May 11, 2021

SCO ID No. 19-20032-02A

## ADDENDUM No. 1

### NCDOT Cherry Branch Ferry Electrical Upgrades

E-1

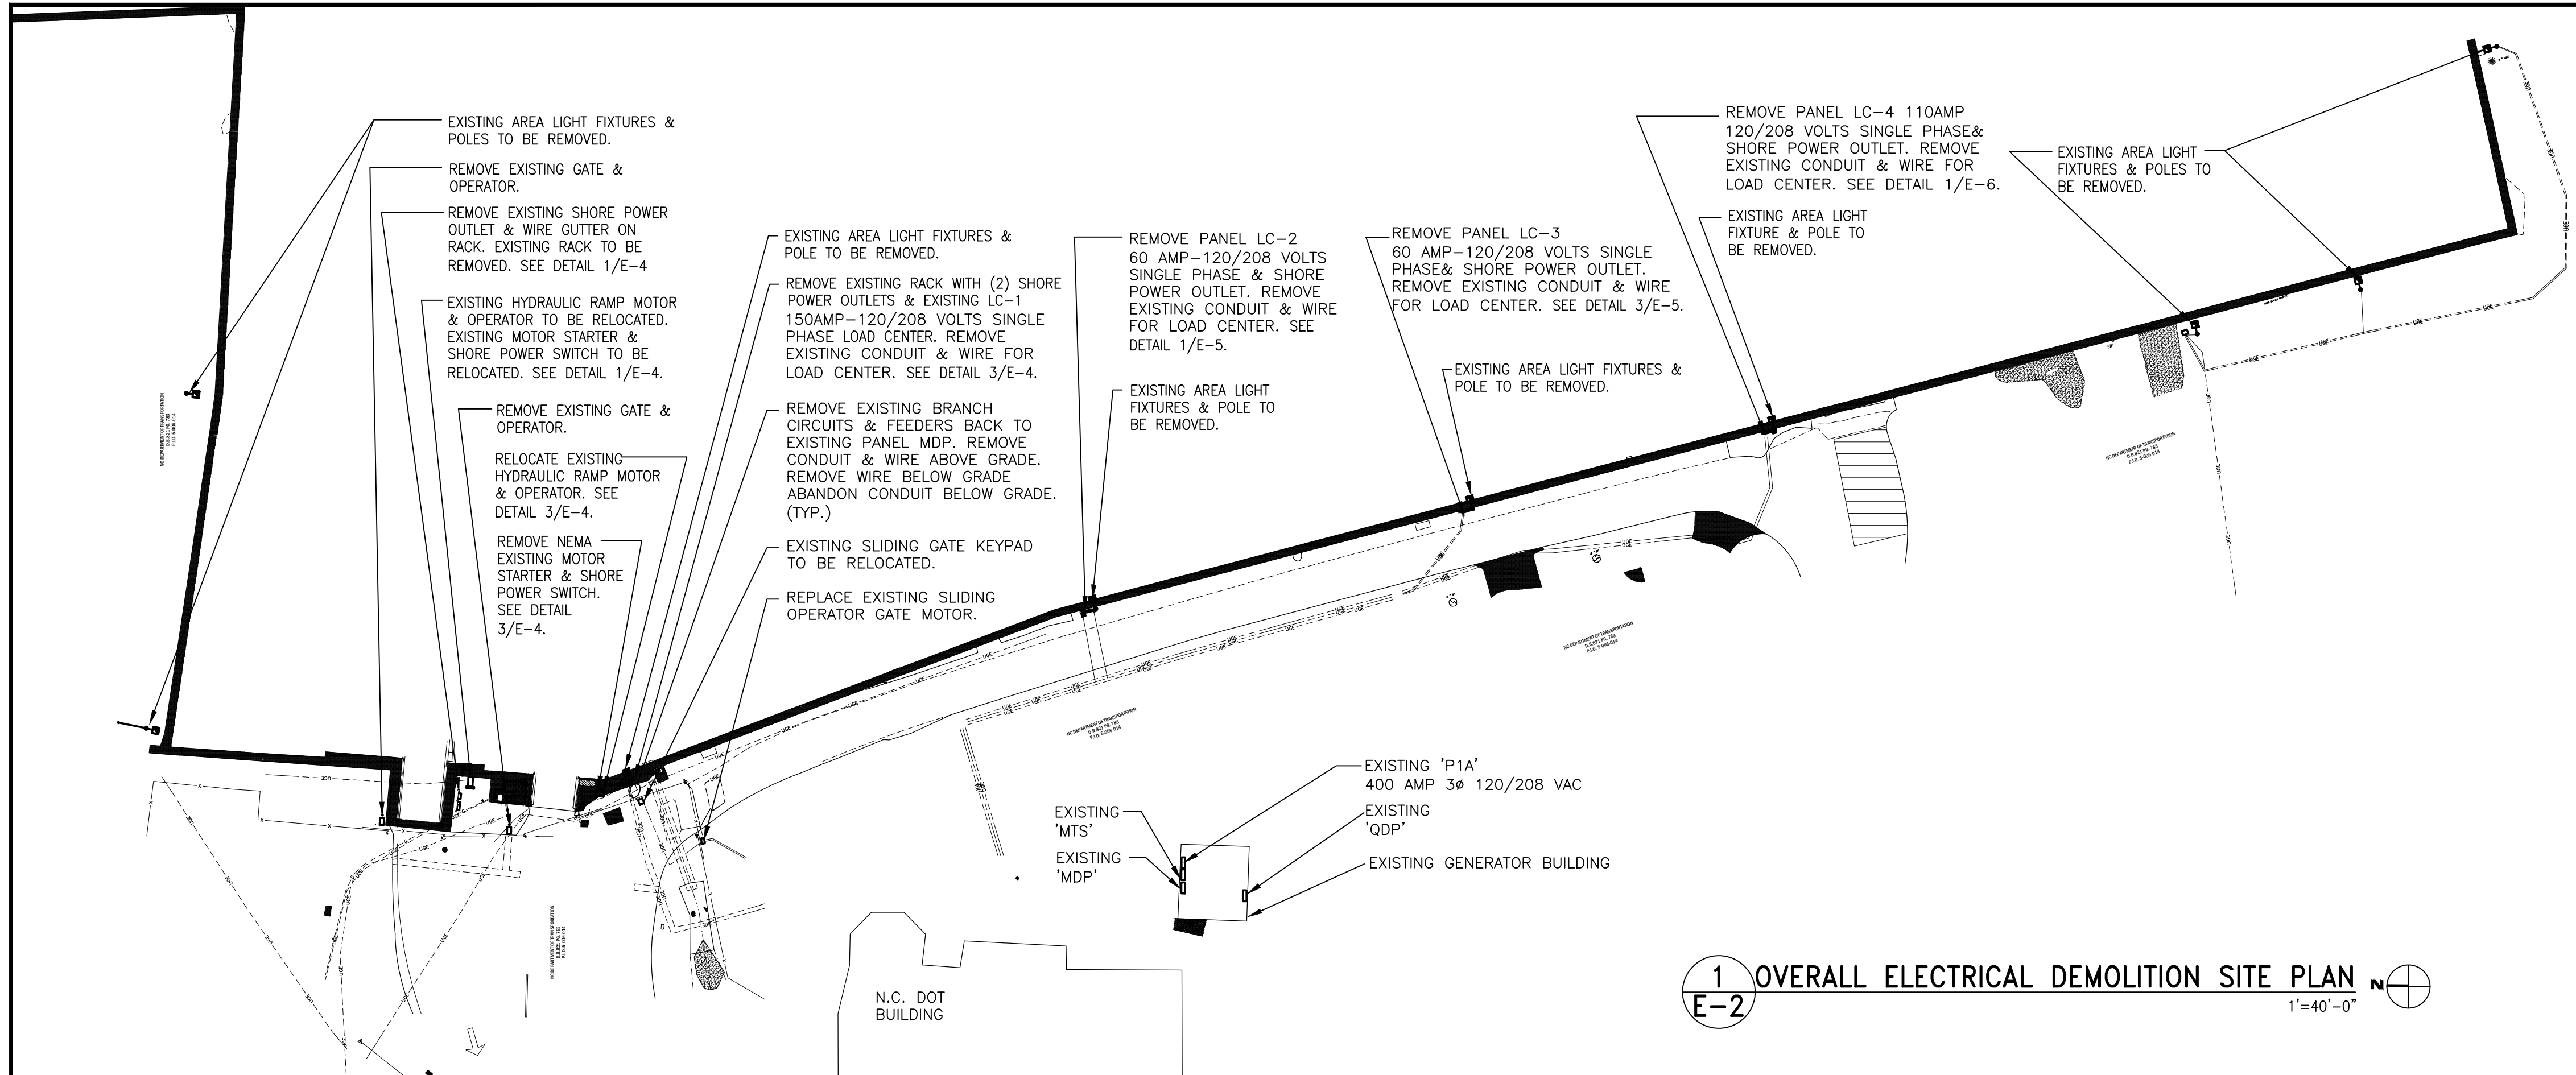
| 1. | Drawing E-1 | Refer to Drawing E-1. Provide new Note 17 as follows: "Provide temporary power from Station #3 Panel LC-2. Provide 60/2 QO breaker in existing load center for Station #1 dock leveler while Station #2 is undergoing demolition. Provide 6/3 with ground cable. Lay cable on bulkhead until Station #2 is complete." See Attachment 'C'. |

16. OBTAIN UTILITY LOCATE PRIOR TO ANY UNDERGROUND DIGGING.
17. PROVIDE TEMPORARY POWER FROM STATION #3 PANEL LC-2. PROVIDE 60/2 GO BREAKER IN EXISTING LOAD CENTER FOR STATION #1 DOCK LEVELER WHILE STATION #2 IS UNDERGOING DEMOLITION. PROVIDE 6/3 WITH GROUND CABLE. LAY CABLE ON BULKHEAD UNTIL STATION #2 IS COMPLETE.

2 OVERALL ELECTRICAL INSTALLATION SITE PLAN  
E-2 1"=40'-0"

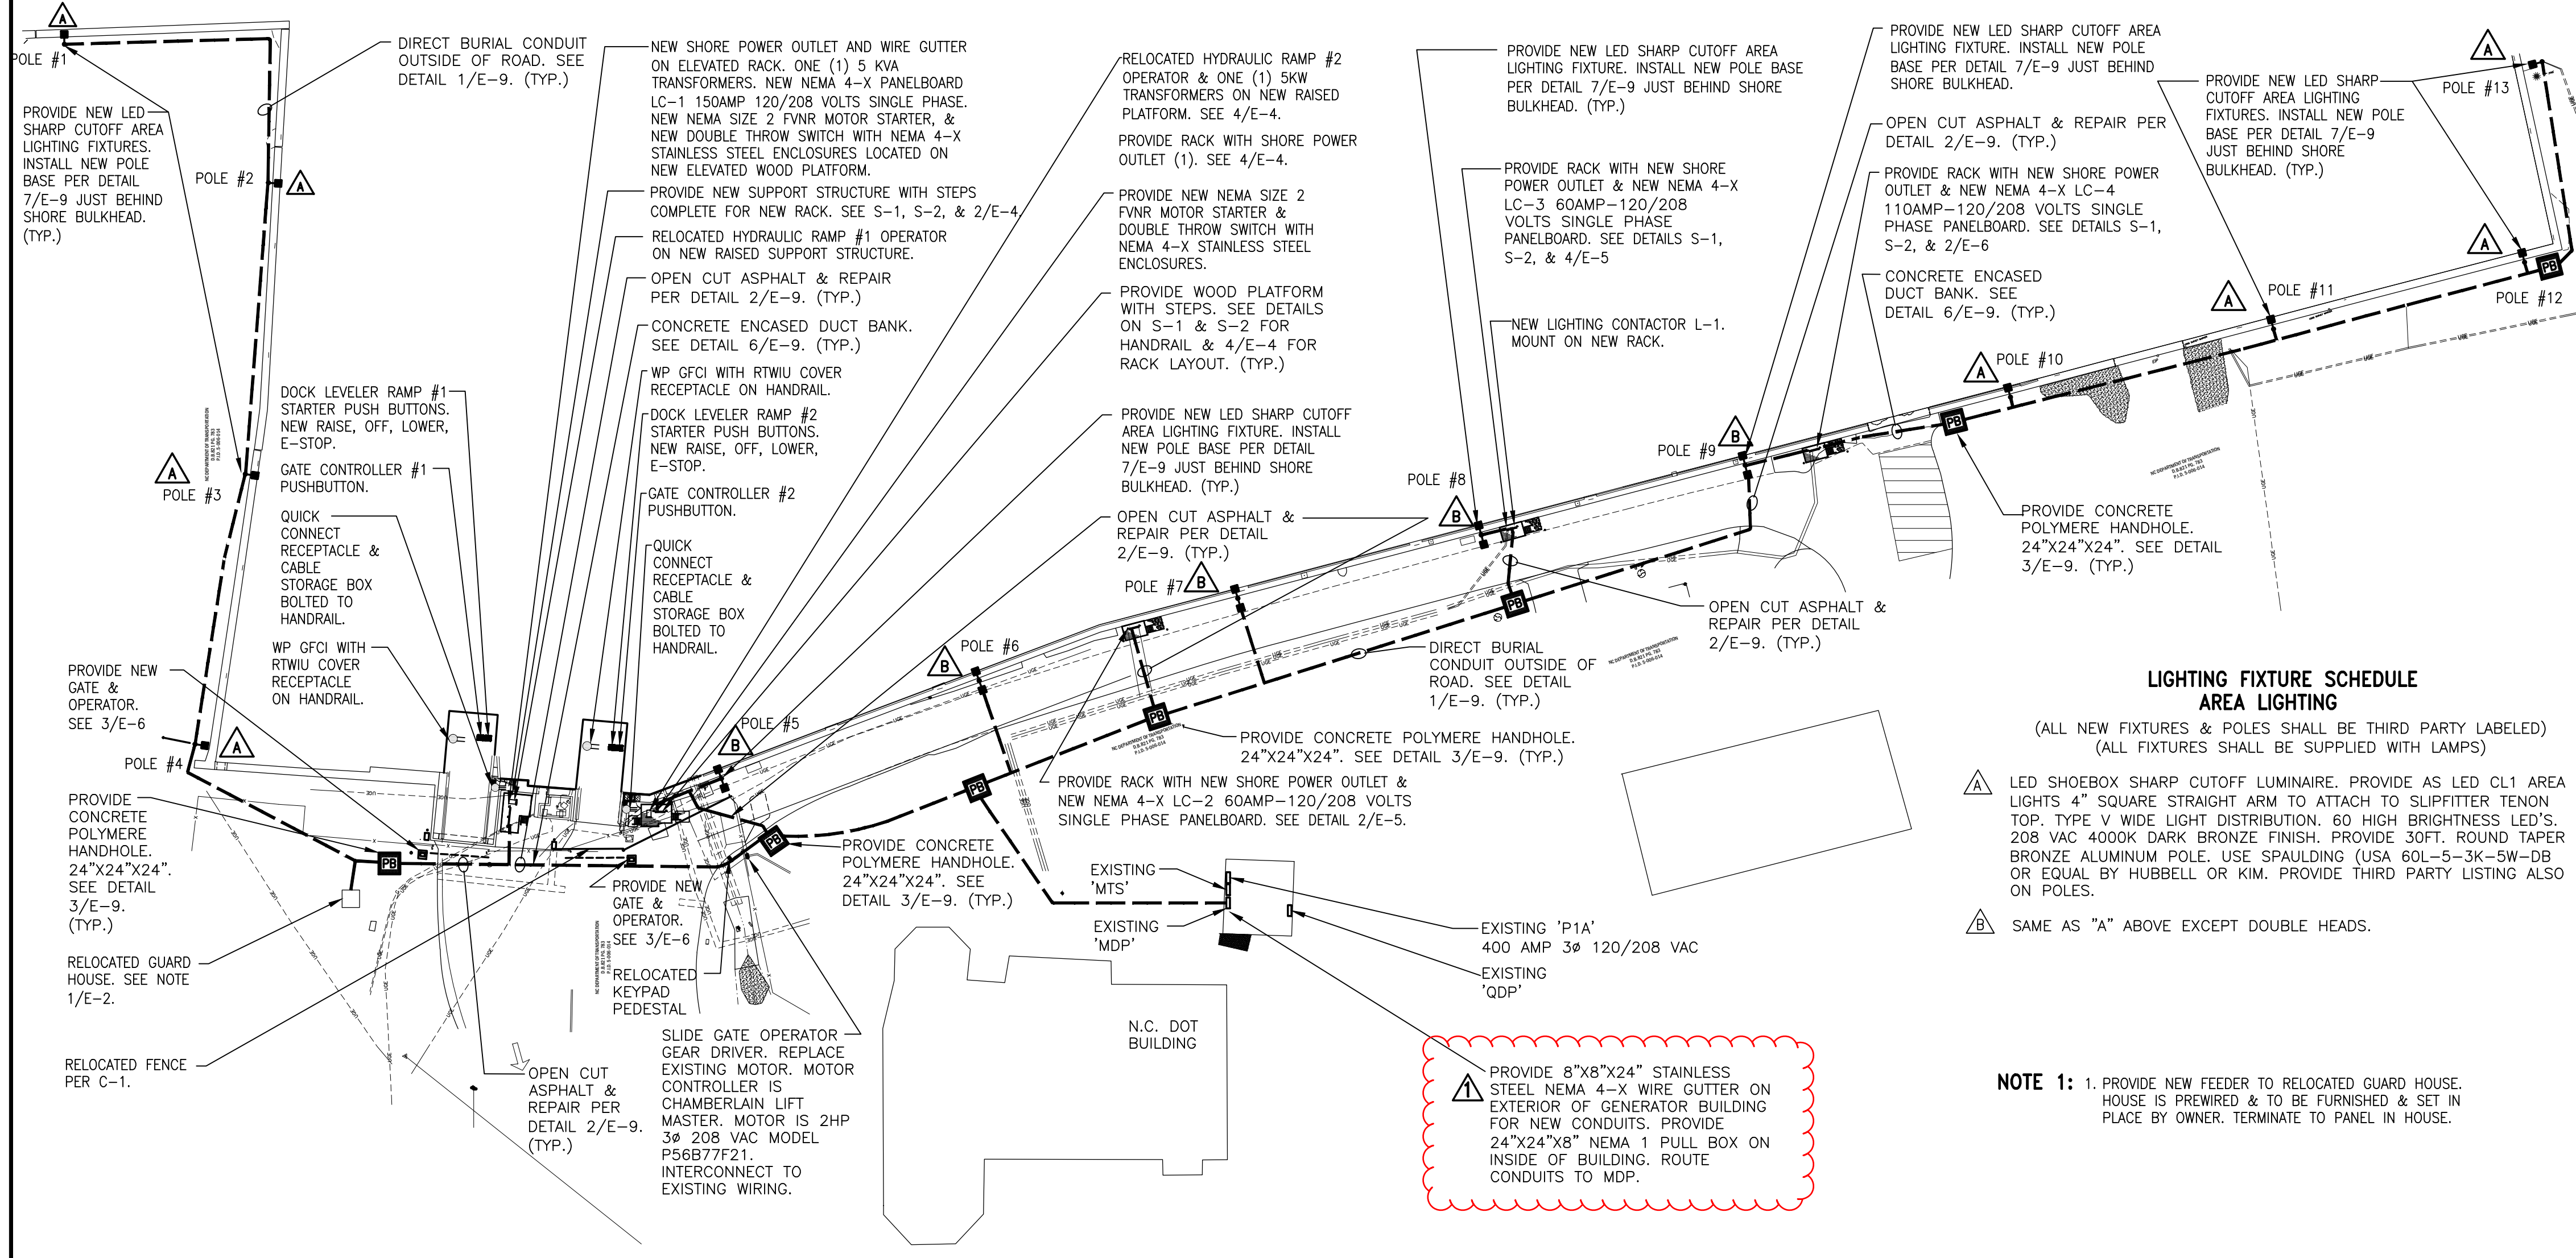
2. Drawing E-2 Refer to Drawing E-2. Provide new note at Generator Building as follows: "Provide 8"x8"x24" stainless steel NEMA 4-x wire gutter on exterior of Generator Building for new conduits. Provide 24"x24"x8" NEMA 1 pull box on inside of building. Route conduits to *MDP*." See Attachment 'D'.

2 INSTALLATION - ONE LINE DIAGRAM  
NTS

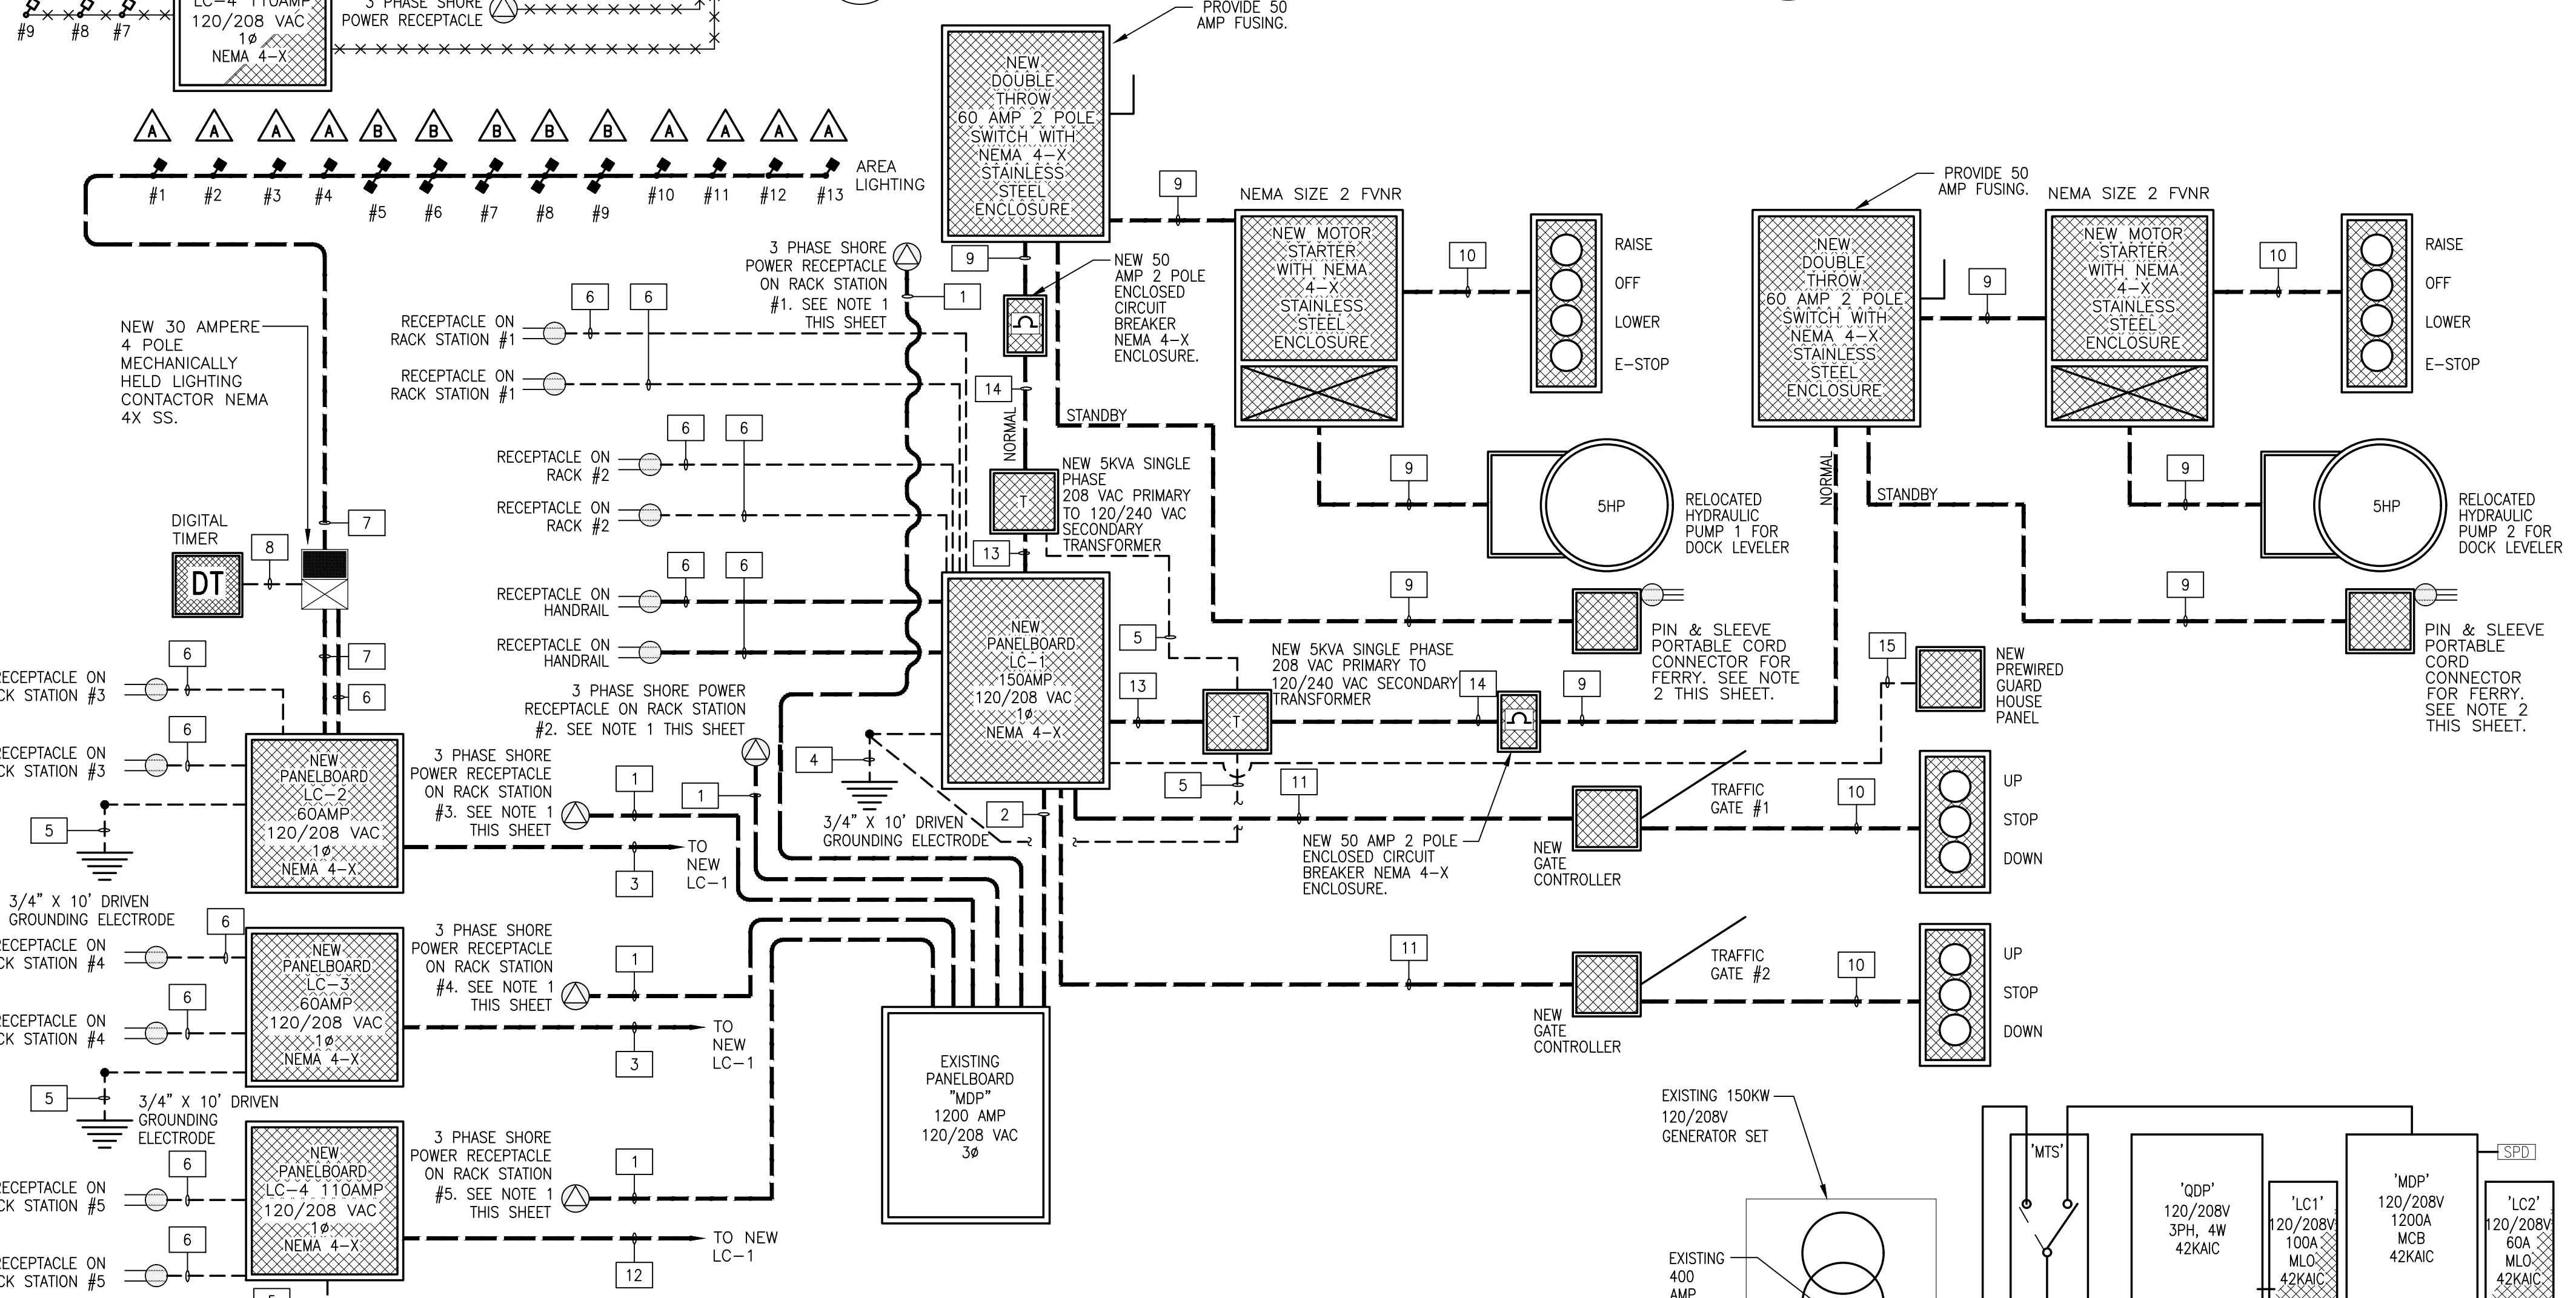
3. Drawing E-7 Refer to Drawing E-7. Provide additional note for conduit 10 on conduit & cable schedule as follows: "Provide flexible weatherproof control cable secured to ferry ramp for traffic arm & dock leveler operation." See Attachment 'E'.

PROVIDE FLEXIBLE WEATHERPROOF CONTROL CABLE SECURED TO FERRY RAMP FOR TRAFFIC ARM & DOCK LEVELER OPERATION.
